Village of Arlington Heights
Plat and Subdivision Committee
Community Room, 3rd Floor
Arlington Heights Village Hall
33 S. Arlington Heights Road
Arlington Heights, IL 60005
April 8, 2015
6:30 PM

STAFF DEVELOPMENT COMMITTEE REPORT

To: Plat and Subdivision Committee
Prepared By: Latika Bhide, Development Planner
Meeting Date: April 8, 2015
Date Prepared: April 2, 2015
Project Title: Holy Nation Presbyterian Church
Address: 2501 N. Chestnut Avenue

To: Plat and Subdivision Committee
Prepared By: Latika Bhide, Development Planner
Meeting Date: April 8, 2015
Date Prepared: April 2, 2015
Project Title: Dolan Realty Advisors on behalf of Verizon Wireless
Address: 800 W. Oakton Street

TOTAL NUMBER OF PARKING STALLS SHOWN HEREON = 62 WHICH INCLUDES 4 HANDICAP STALLS.

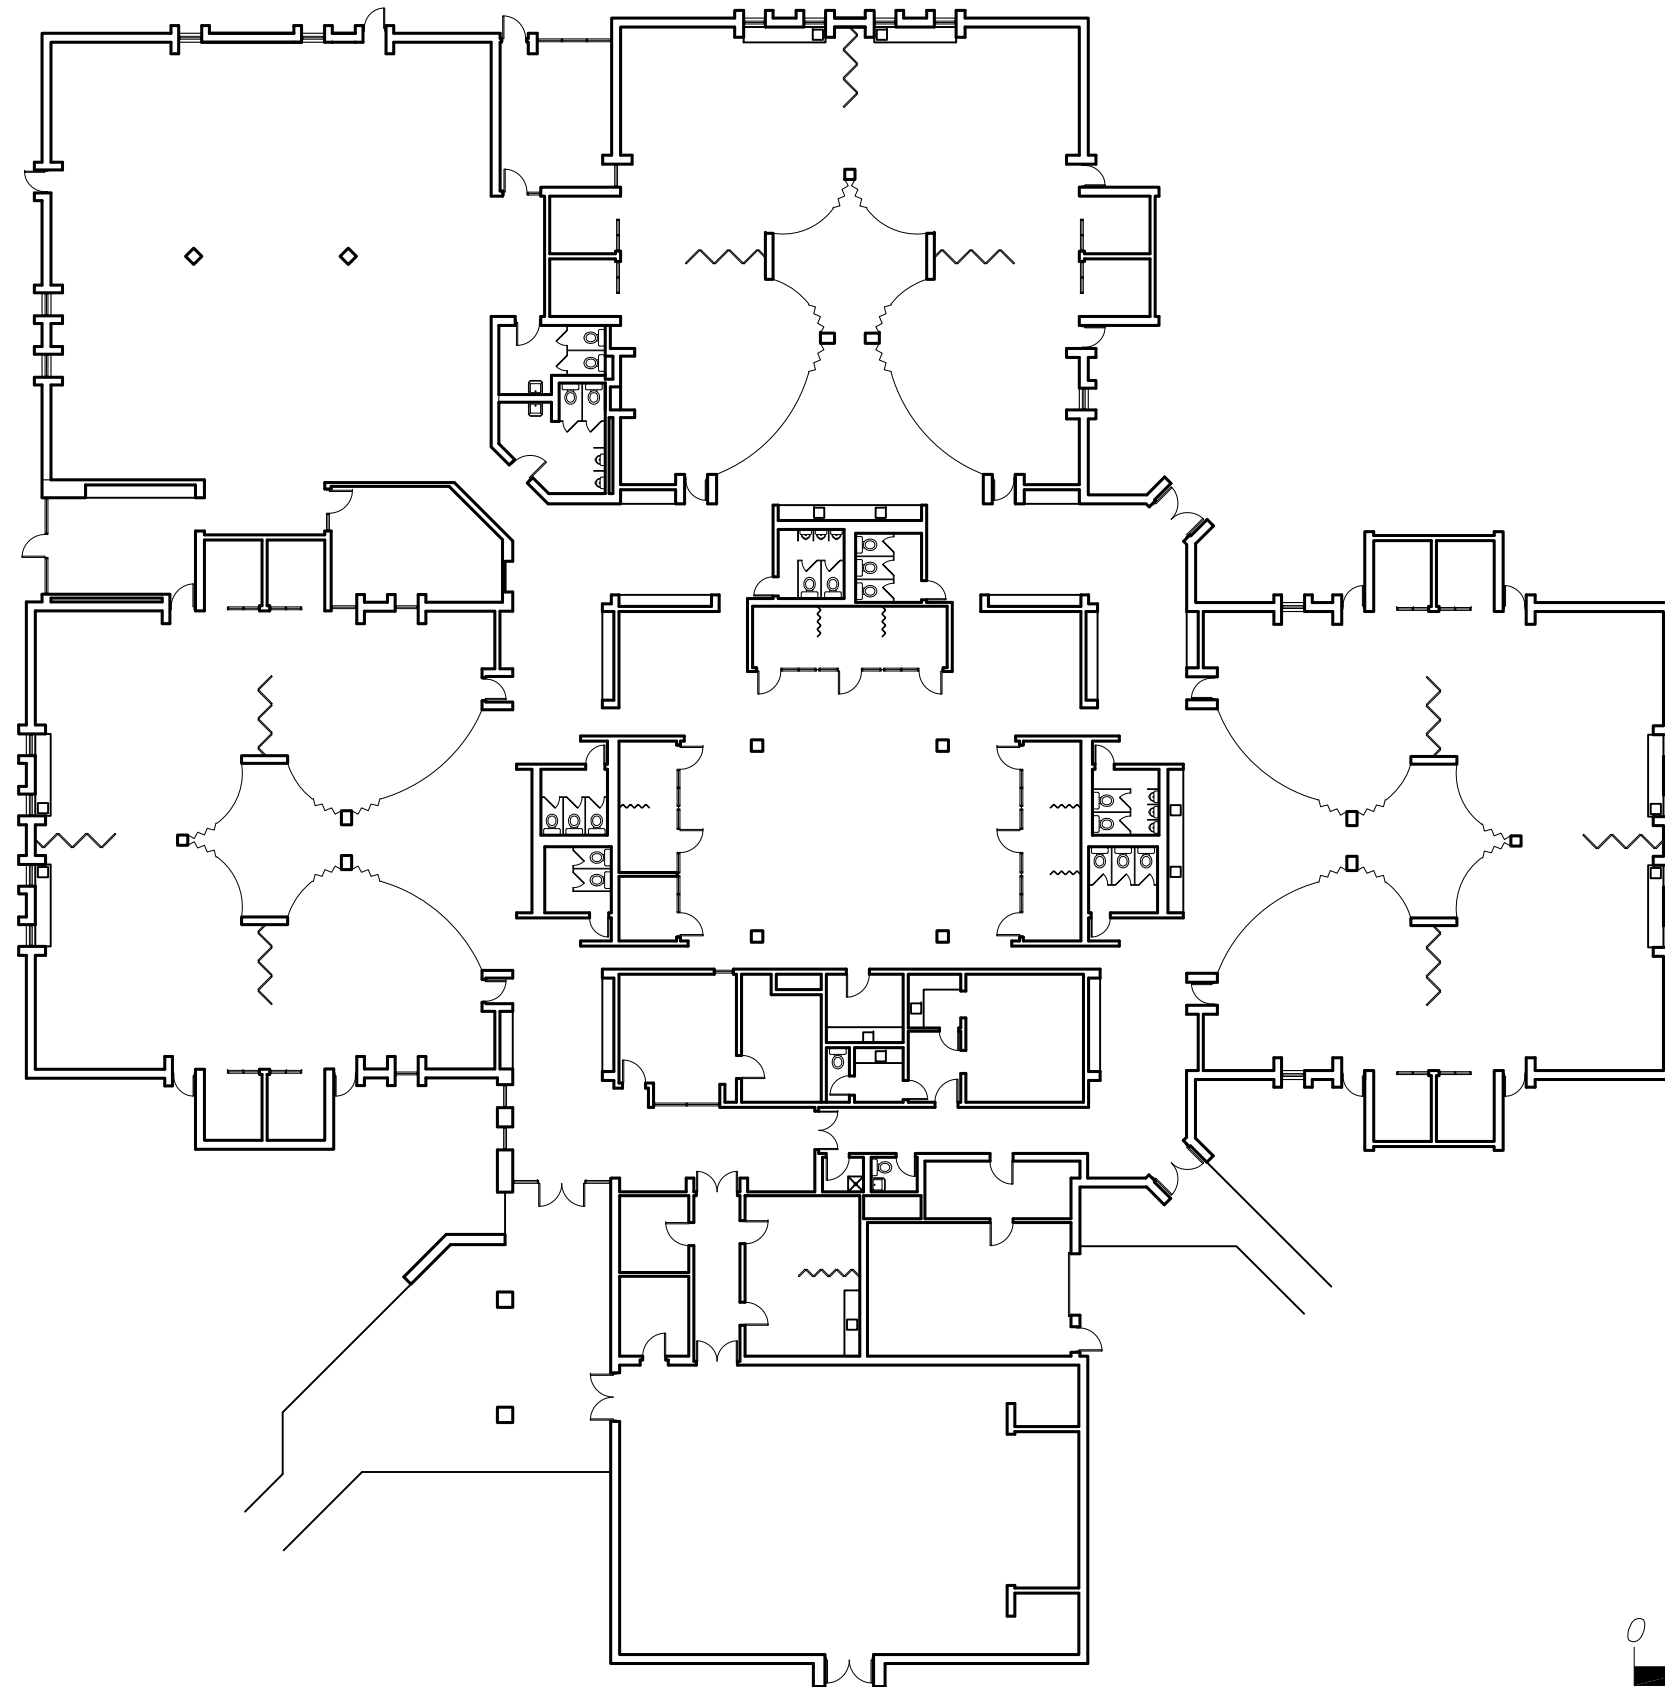
1. A variation from Chapter 28, Section 11.4, Schedule of Parking Requirement to allow a reduction to the required number of parking stalls from 279 spaces to 62 spaces, a variation of 217 spaces.

Per Chapter 28, a three-foot high continuous row of shrubs is required to screen the parking lot from the public view (Waverly Dr. and Chestnut Ave.), and curbed islands with shade trees at the end of each row of parking and after every 20 parking stalls are required for the parking lot. It appears that there is a continuous row of shrubs along Waverly Dr. and Chestnut Ave. as well as curbed islands with shade trees. The landscaping will need to be reviewed as part of the formal Plan Commission review to determine if Code is being met.

1 EAST ELEVATION
SCALE: 1/8" = 1'-0"

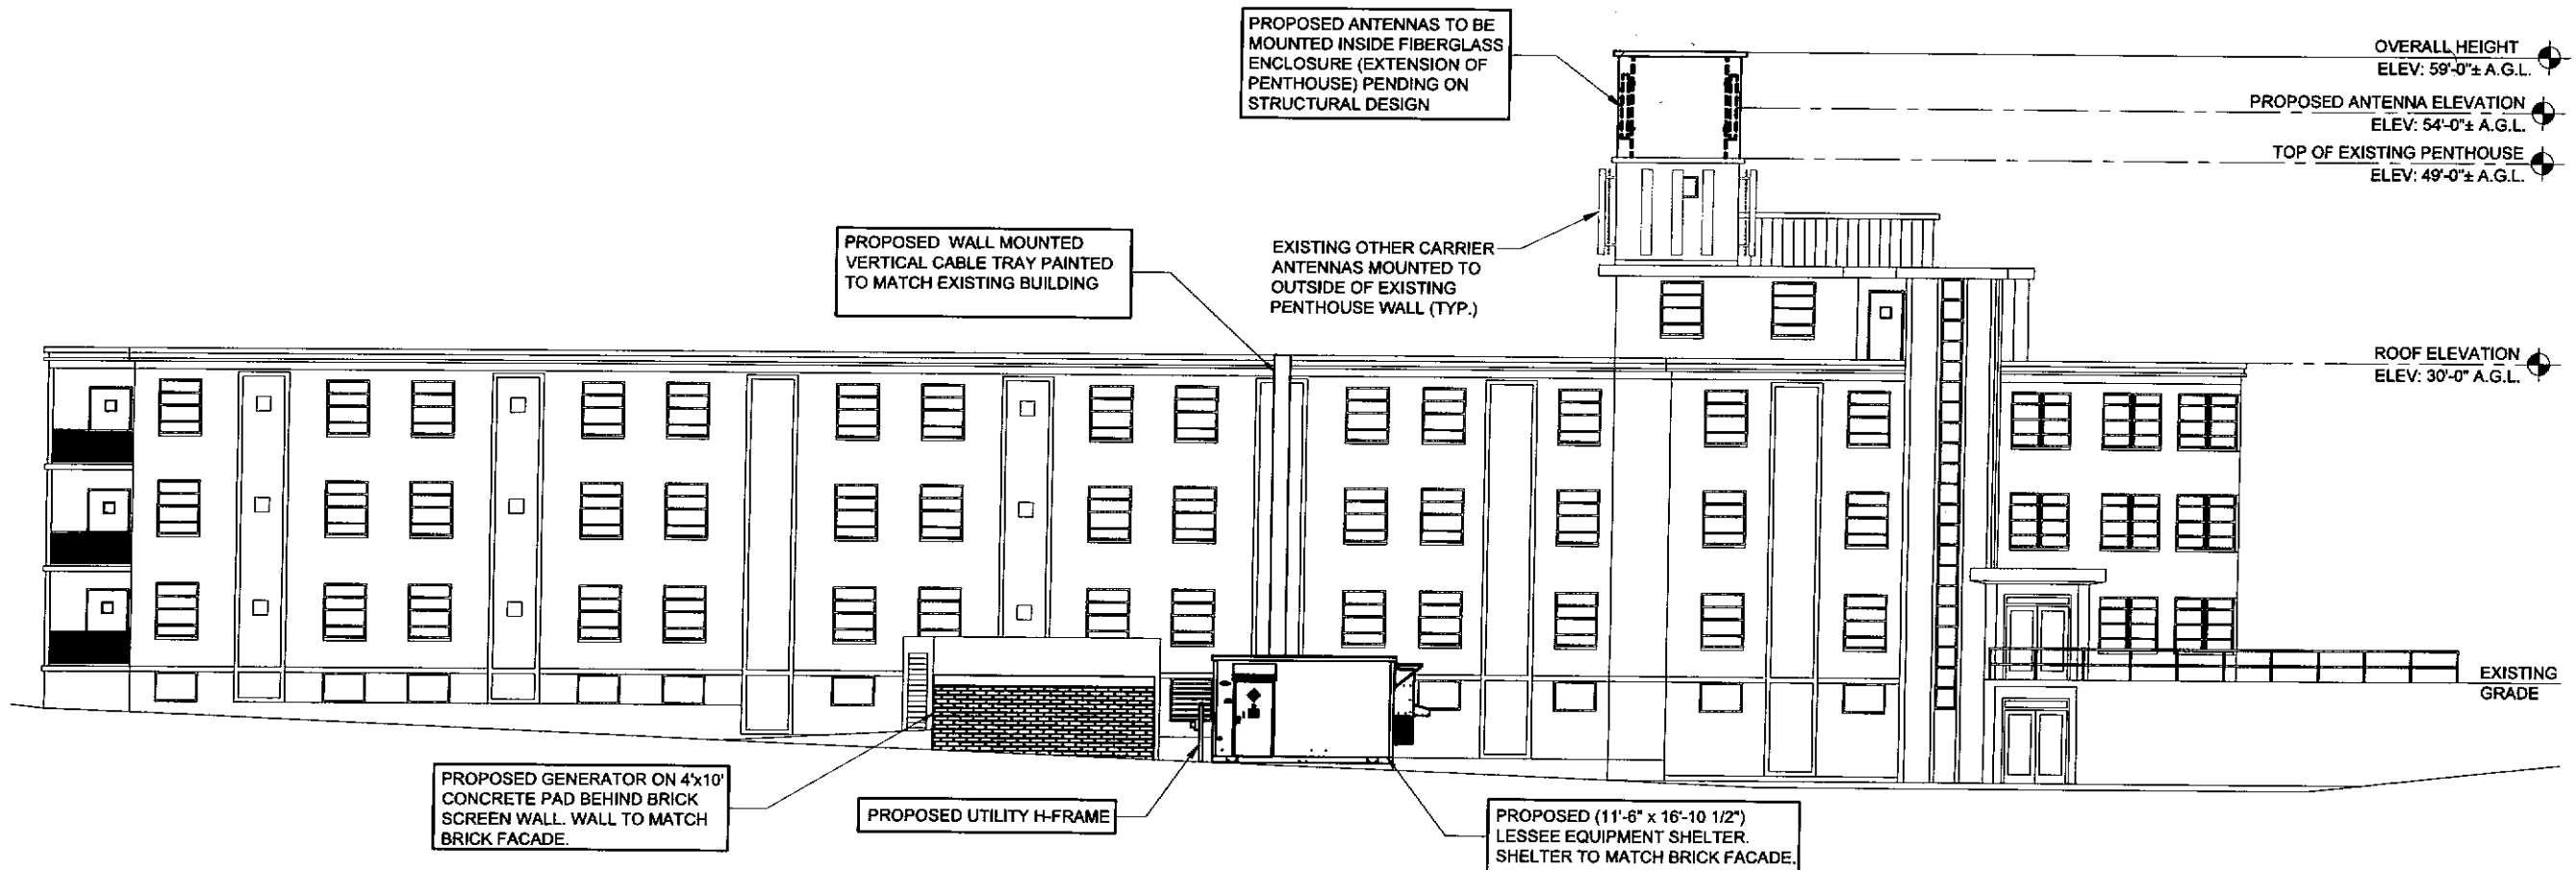
- **The proposed antennas project more than 12 feet from the highest point of the roofline of the building.**
The roofline of the building in question is at 30' (this height is indicated to the top of the parapet wall, not the roof deck. As part of the formal Plan Commission review, the height to the roof deck must be provided). The total height of the building, lower penthouse, elevator shaft and the proposed enclosure for the antennas will be 59 feet, which is 29 feet higher than the roofline of the building.

- **The antennas do not blend in with the existing architectural character of the building.**
The antenna enclosure is proposed on top of the elevator shaft/penthouse which is located on top of the lower penthouse. The lower penthouse, elevator shaft/penthouse and the proposed enclosure are 29 feet above the roofline of the building and it questionable whether they would blend in with the existing architectural character of the building.

The Staff Development Committee has concerns with the proliferation of the antennas at this site as well as the proposed location of the antennas, sited higher than the elevator shaft/penthouse. Verizon Wireless has indicated that they have evaluated other alternatives in the search area, including building a new tower, existing towers and collocating on the Arlington Heights Water Tank. They have indicated that they cannot provide a site with more concealment than the proposed site as the proposed antennas will be concealed behind a screen wall that will be painted to match the existing penthouse.

1 ENLARGED SITE PLAN
SCALE: 1" = 10'

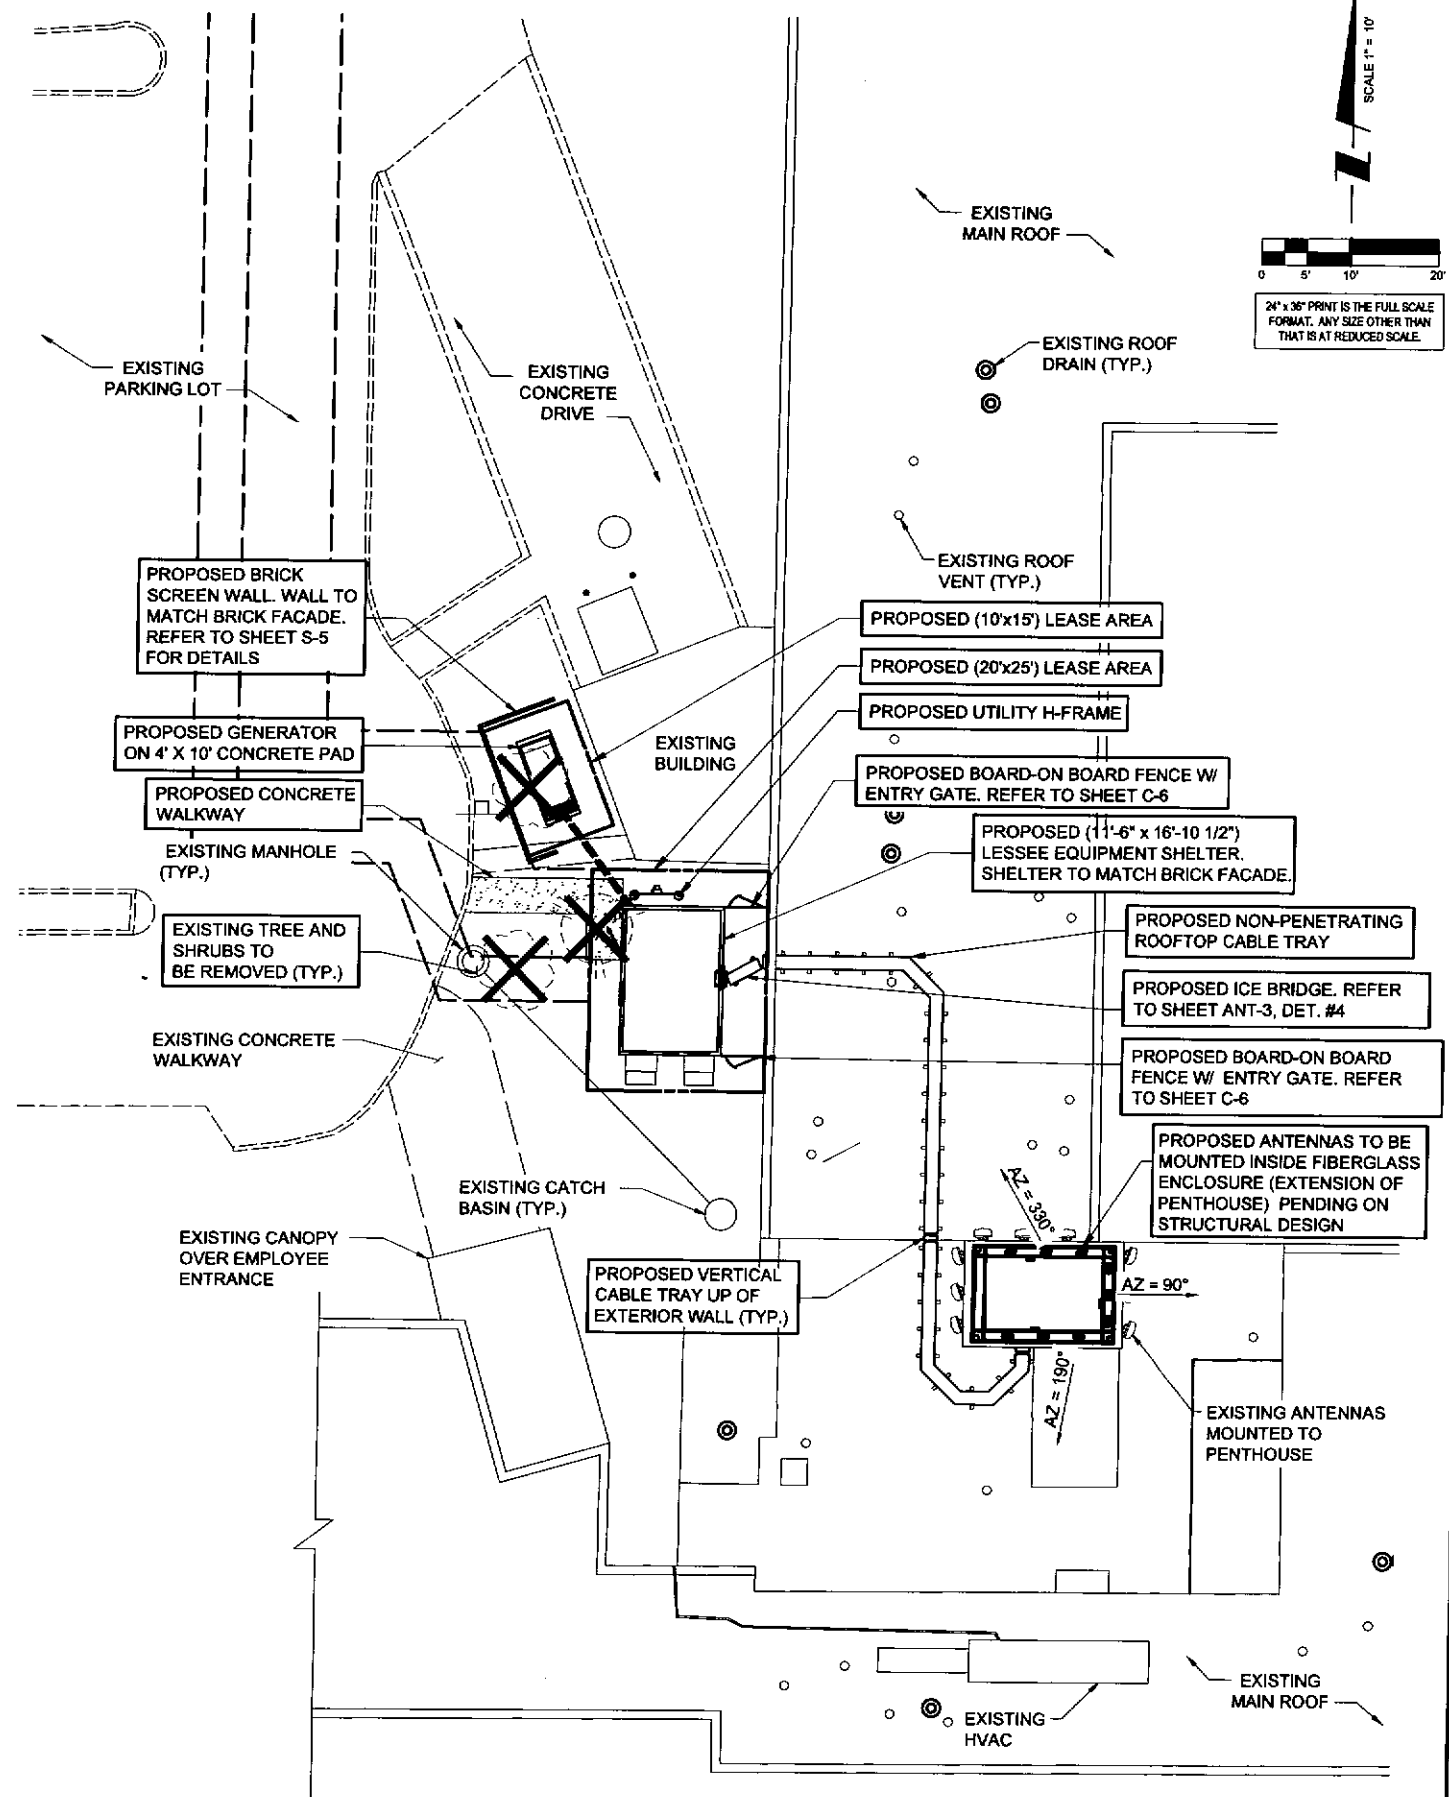
The petitioner is proposing a generator pad and equipment shelter on the west side of the building in question. Per the plans provided, three trees are proposed to be removed to accommodate the generator pad and equipment shelter. As part of the formal Plan Commission submittal, the petitioner must provide information on the trees to be removed and replacement trees as required per the Ordinance must be provided.
